ADDENDUM # 2

Reference: Utah National Guard – Camp Williams
JLTC Building #3
DFCM Project No. 05020480

PROJECT: JLTC – Building #3
Project No. - 05020480
Camp Williams
Draper, UT 84065

WALL AT STRUCTURE DETAIL

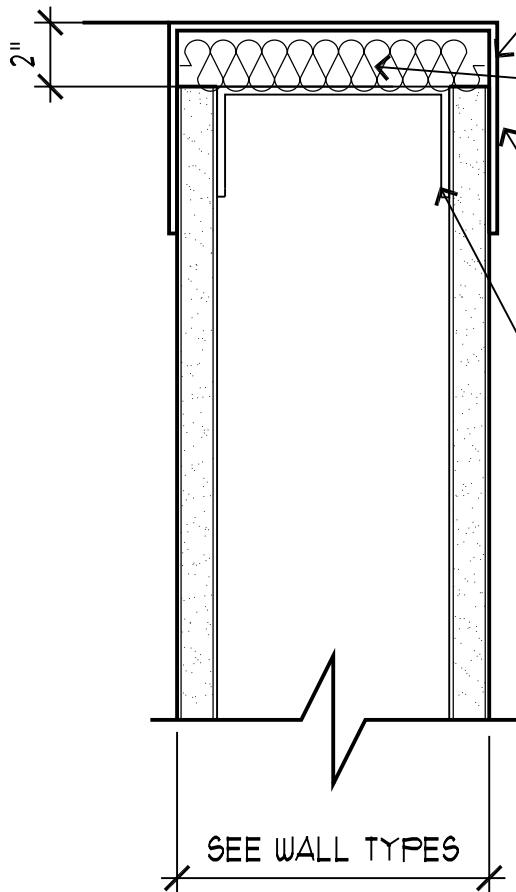
9. SHEET A-501 Wall Types and Architectural Details:
 - 9.1. Detail A1 – This detail must be revised to follow the UL rated construction of UL #HW-D-0054 (2003, Volume 2-A), see the attached detail. This detail needs to be used at the top of all "B" type walls along the rated Hallway 101.

INSTALL AS PER UL* HW-D-0054(2003- VOL 2A)
FOR A 1 HR ASSEMBLY

JOINT SYSTEM INSTALL AS PER UL
NOTES WITH 3" MAX. DEEP MIN. 24
GAUGE GALV. STEEL CHANNEL
SIZED TO ACCOMMODATE CEILING
RUNNER FASTENED AT 24" O.C.

FORMING MATERIAL: MIN $\frac{5}{8}$ " OR $1\frac{1}{4}$ "
WIDE STRIPS OF 6PCF DENSITY
MINERAL WOOL.

SEALANT: MIN $\frac{1}{8}$ " WET THICKNESS
OF FILL MATERIAL SPRAY
APPLIED ON EACH SIDE OF THE
WALL BETWEEN TOP OF WALL AND
THE BOTTOM OF THE ROOF DECK
AND OVERLAP A MIN. OF $\frac{1}{2}$ " ONTO
GYP. BRD. (SPECSEAL AS 200
ELASTOMERIC SPRAY OR EQUAL)

METAL STUD WALL - SEE PLANS
FOR WALL TYPE. THE SCREWS
ATTACHING THE GYP BRD. TO THE
STUDS ALONG THE TOP OF THE
WALL SHALL BE LOCATED 1"
BELOW THE BOTTOM OF THE
CEILING RUNNER. NO WALLBOARD
ATTACHMENT SCREWS SHALL BE
DRIVEN INTO THE CEILING RUNNER
OR INTO THE OPTIONAL
DEFLECTION CHANNEL.
